Historical Areas Board of Review(HABR)

Project Name: B. Meyer 23 Closter Rd, Palisades #1

Changes were made to the original plans based on the following:

Approved on original plan and what was used instead.

JOB NO.:	DWG. NO.
DATE: 08.14. 2023	A-201
SCALE: AS NOTED	
DRAWING BY: KWB

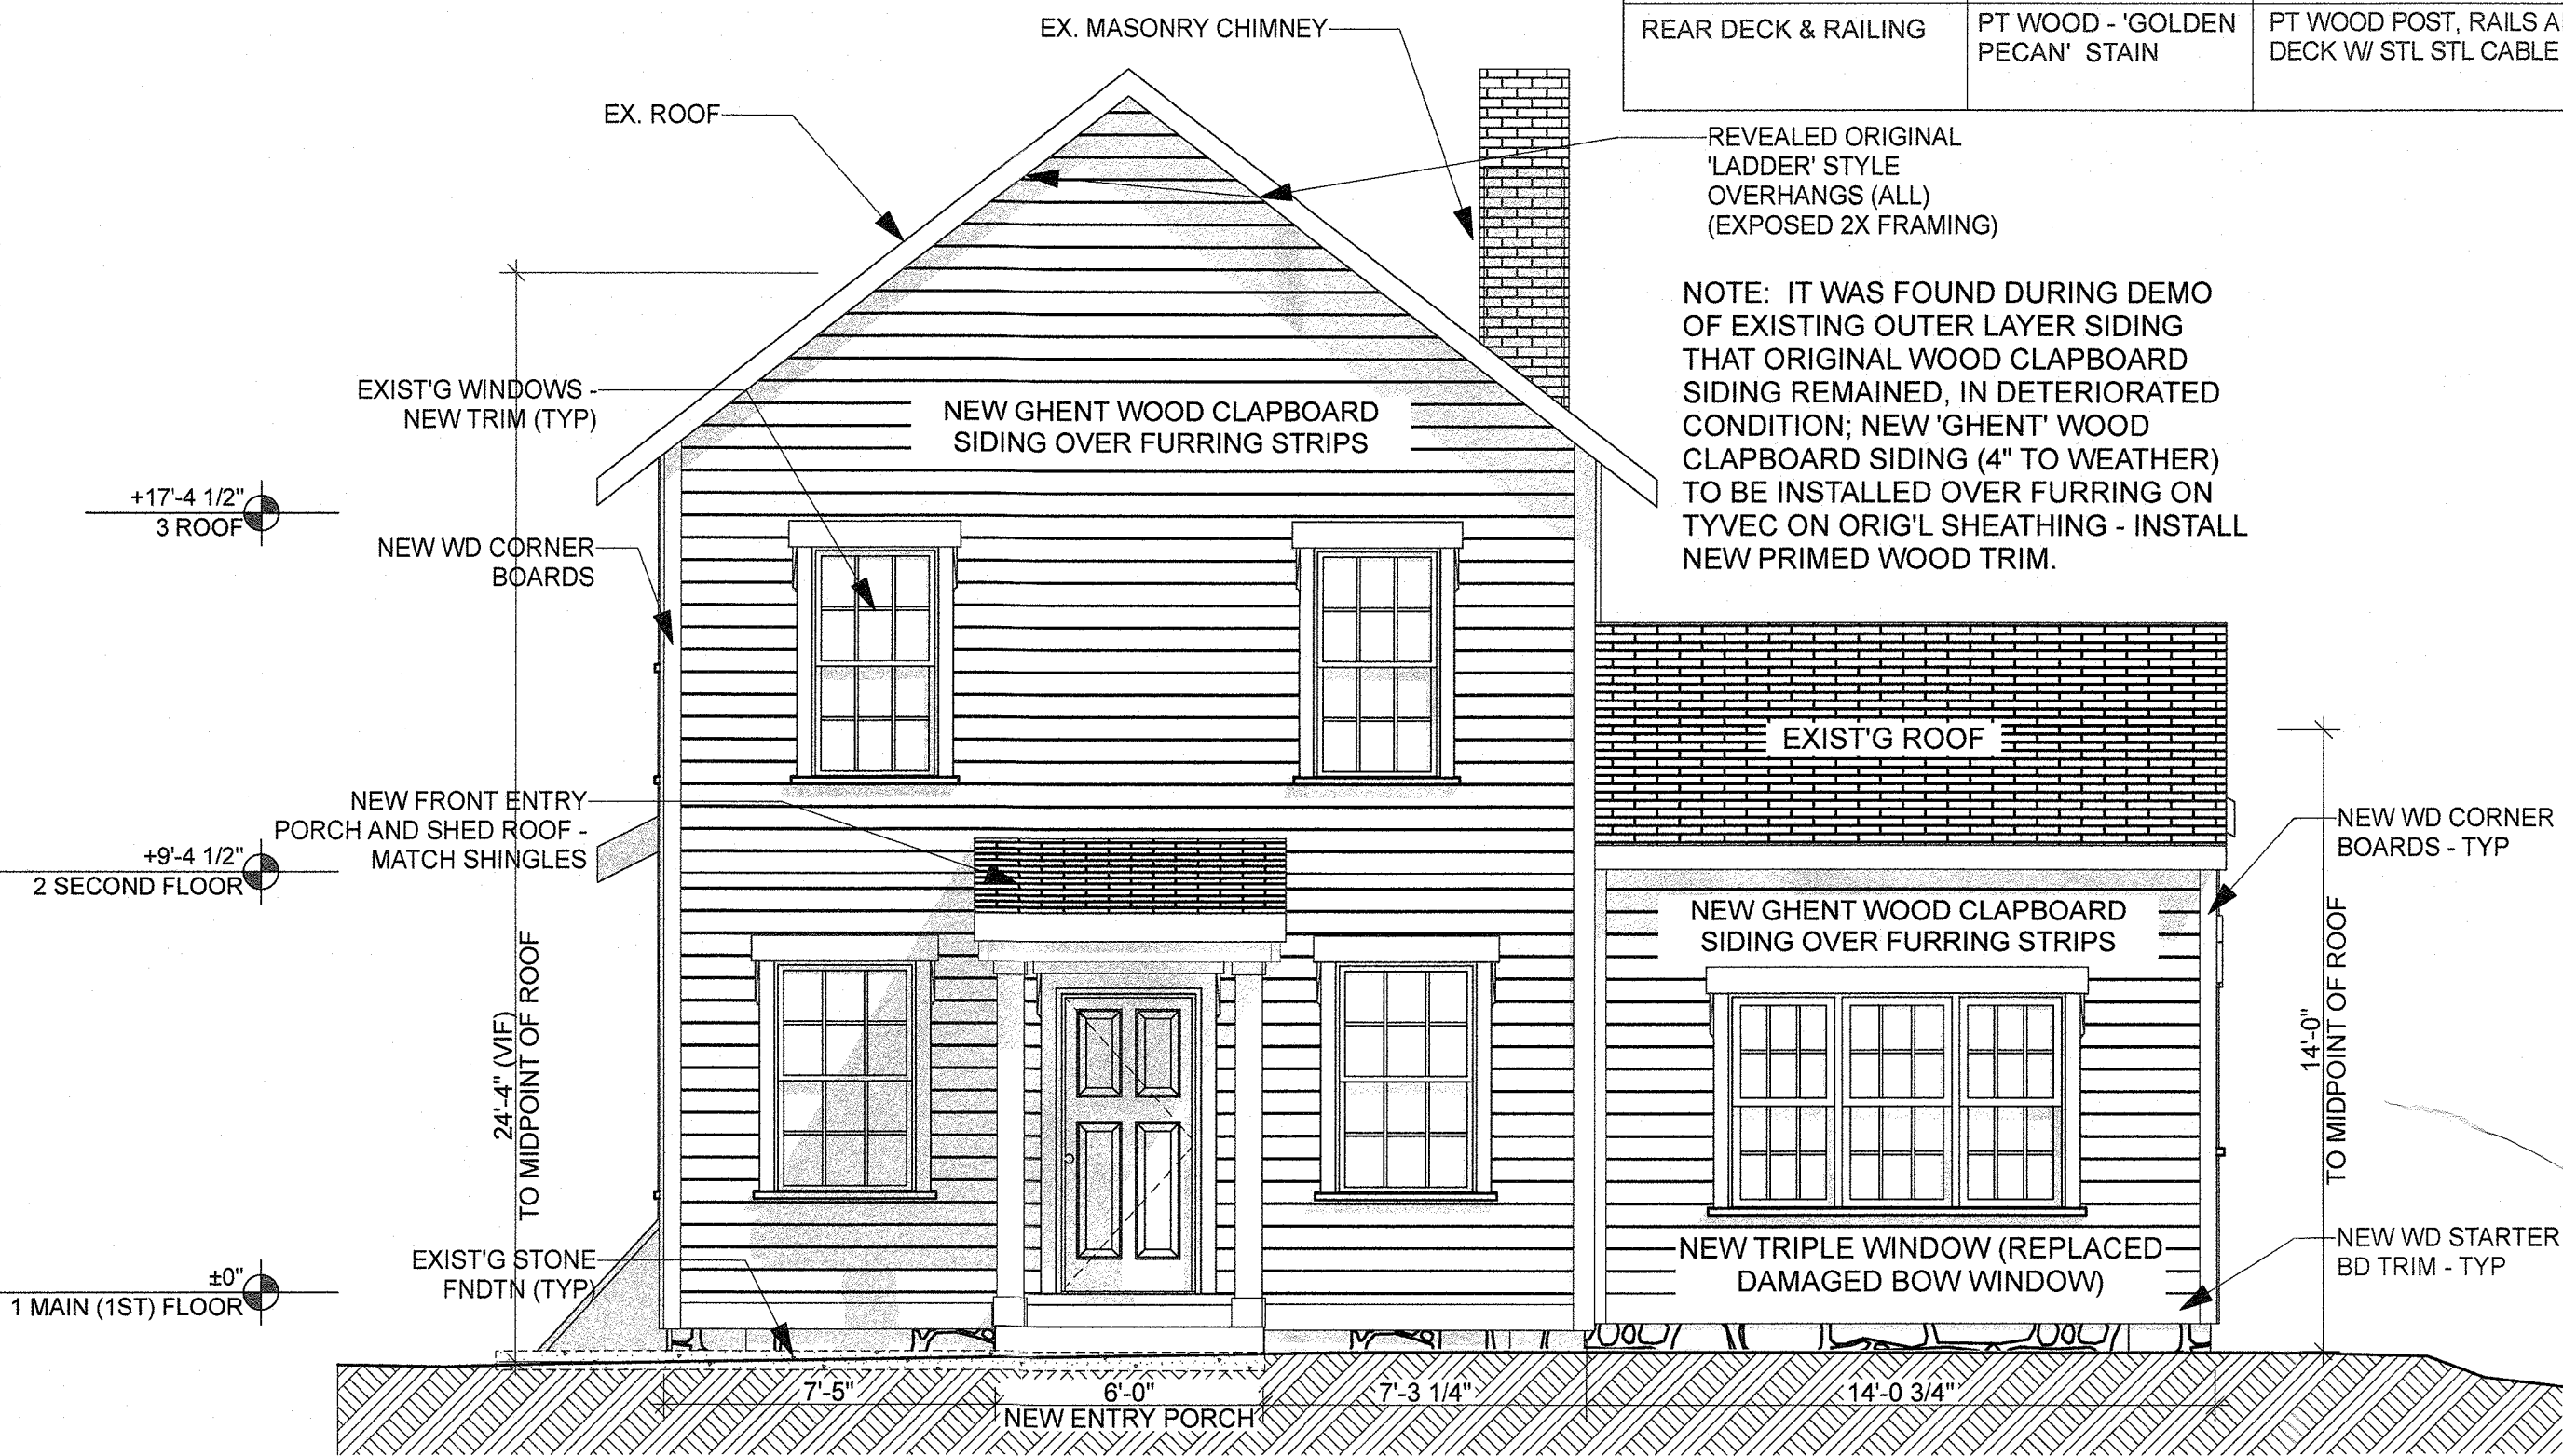
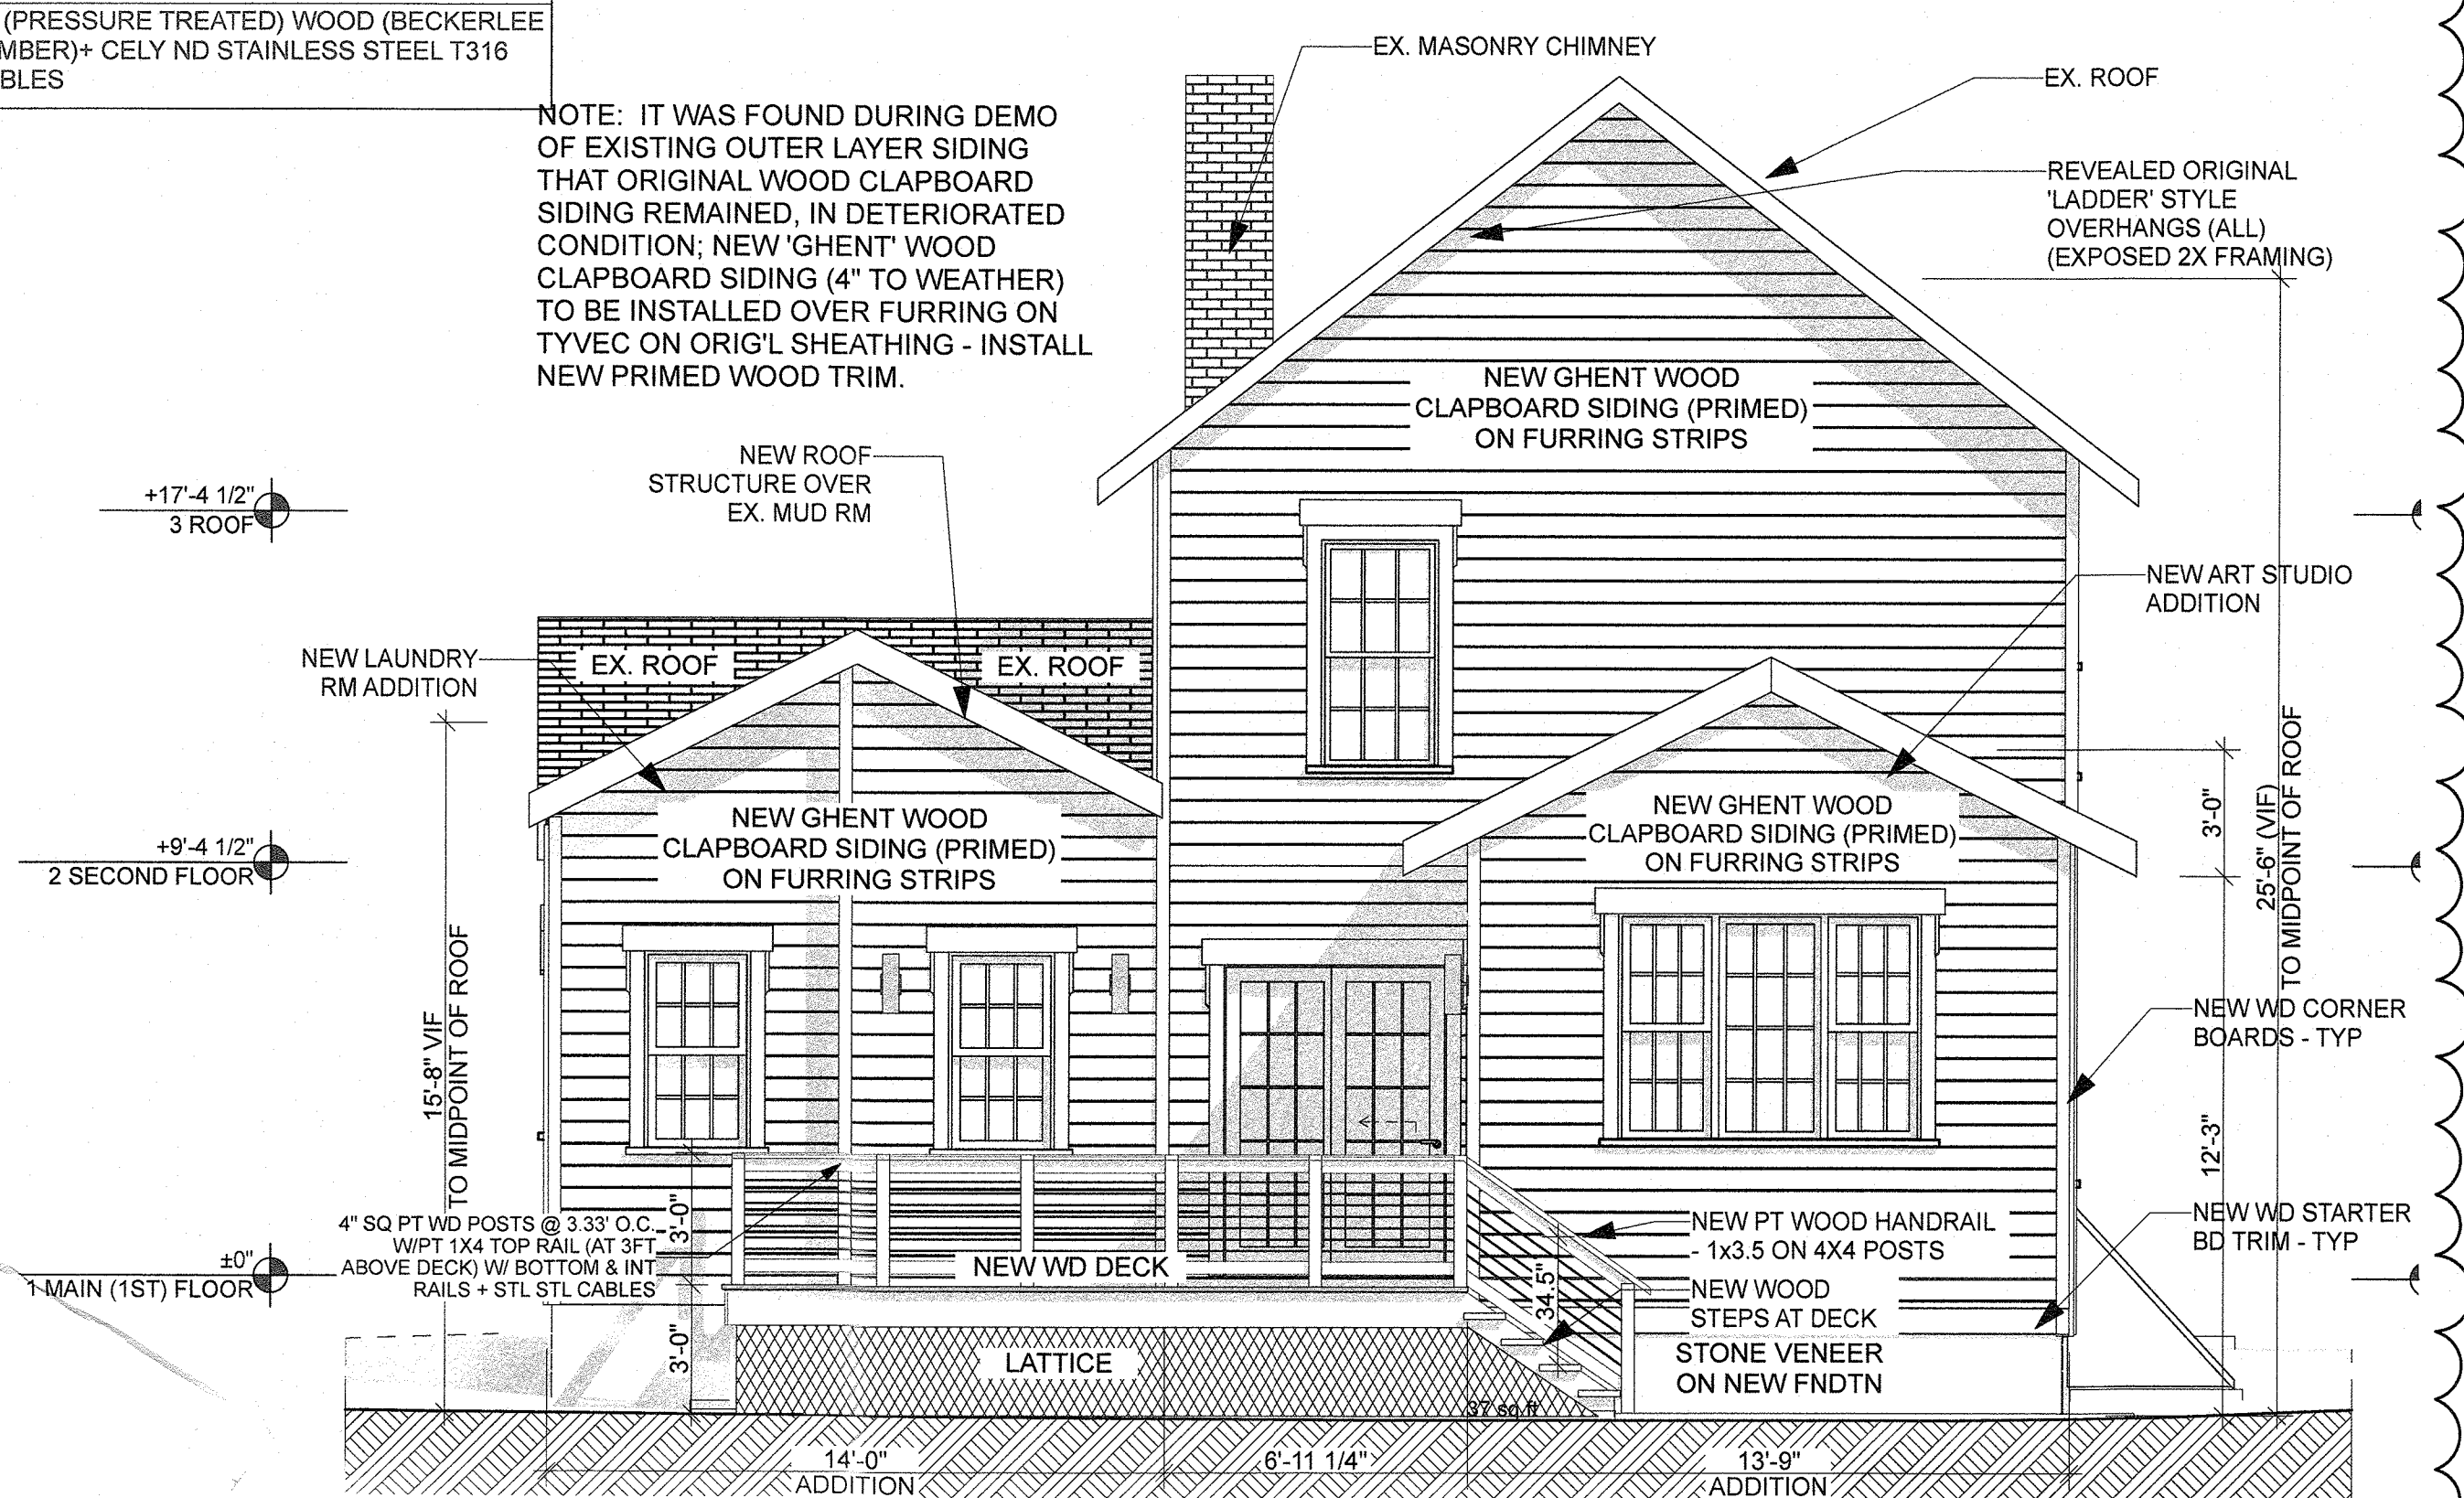
MATERIALS AND FINISH SCHEDULE			
ITEM	COLOR	MATERIAL	MANUFACTURER
ROOF	CHARCOAL	FIBERGLASS SHINGLES	GAF TIMBERLINE 'NS' - MATCH EXIST
SIDING	WHITE	GHENT WOOD CLAPBOARD SIDING W/ 4" TO WEATHER	GHENT LUMBER-
SOFFITS, FASCIA, GUTTERS	WHITE	PRIMED WD SOFFIT+FASCIA ALUMINUM GUTTERS	PLYGEM OR ROLLEX (GUTTERS)
WINDOWS, SLIDING DRS	WHITE	VINYL CLAD	MI 1600 SERIES; DOUBLE HUNG & SLIDING DRS
TRIM	HISTORIC SAGE	PRIMED WOOD TRIM BOARD	GHENT LUMBER
STONE OR ROCK	MATCH EX. STONE	CULTURED STONE	TO MATCH EXISTING FOUNDATION
REAR DECK & RAILING	PT WOOD - 'GOLDEN PECAN' STAIN	PT WOOD POST, RAILS AND DECK W/ STL STL CABLE RAIL	PT (PRESSURE TREATED) WOOD (BECKERLEE LUMBER)+ CELY ND STAINLESS STEEL T316 CABLES

REVEALED ORIGINAL 'LADDER' STYLE OVERHANGS (ALL) (EXPOSED 2X FRAMING)

NOTE: IT WAS FOUND DURING DEMO OF EXISTING OUTER LAYER SIDING THAT ORIGINAL WOOD CLAPBOARD SIDING REMAINED, IN DETERIORATED CONDITION; NEW 'GHENT' WOOD CLAPBOARD SIDING (4" TO WEATHER) TO BE INSTALLED OVER FURRING ON TYVEC ON ORIG'L SHEATHING - INSTALL NEW PRIMED WOOD TRIM.
